REV.
D

BOLT, MACHINE - DOUBLE HEXAGON EXTENDED
WASHER HEAD, CLOSE TOLERANCE SHANK,
UNS S66286, 130 KSI MIN, .1900-32 UNJF-3A

AS91101™
SHEET 1 OF 2

ISSUED 1999-12 REVISED 2022-08

FIGURE 1 - BOLT

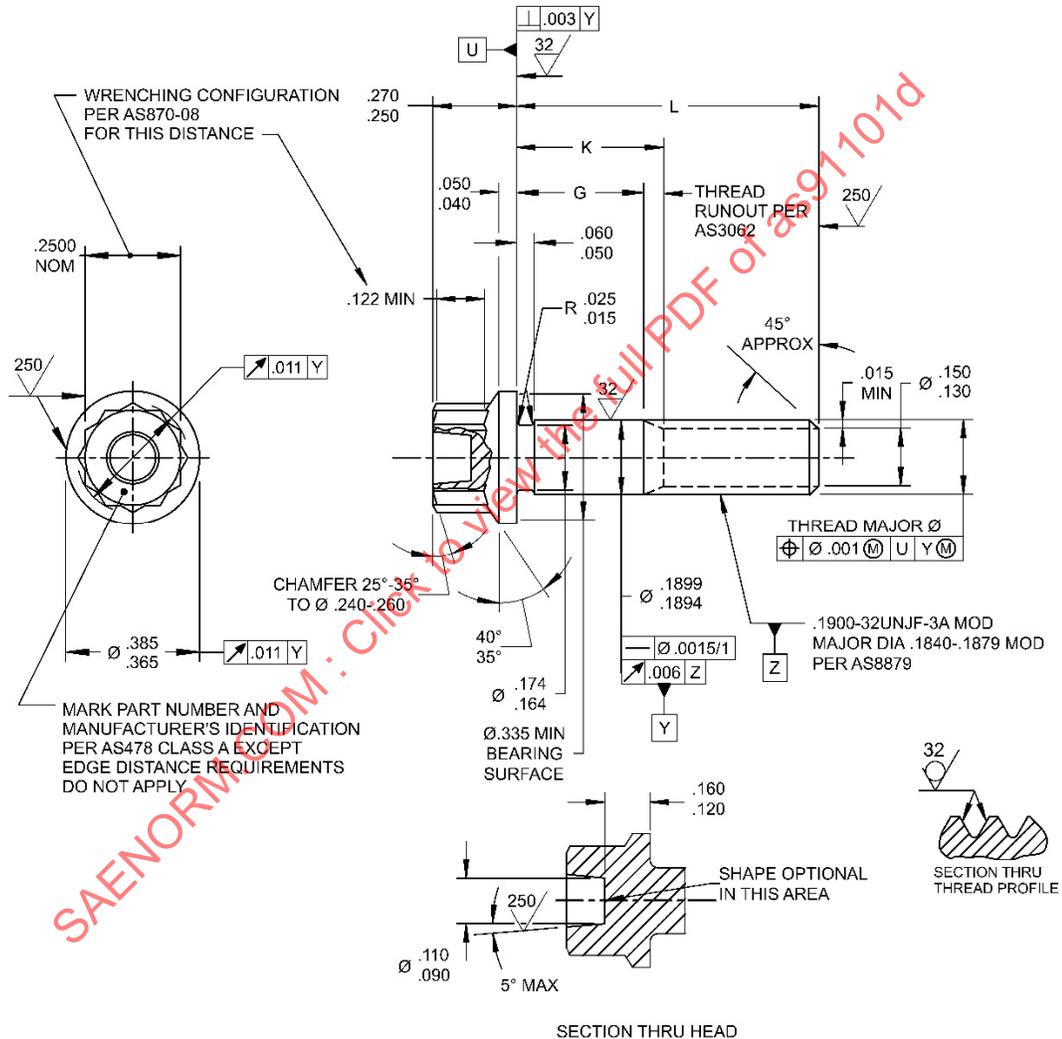
UPDATE TO ASME Y14.5-2018. DELETE RUNOUT REQUIREMENT ON SHANK TO DATUM M AND ADD POSITION TOLERANCE ON MAJOR DIA (ADD DATUM U ON BEARING FACE) PER AS1132. REVISE LEAD THREAD CHAMFER TO AS1132. REVISE LIGHTENING HOLE CONFIGURATION TO AS1132. NOTE 1 - ADD "COMPOSITION SIMILAR TO" TO UNS.
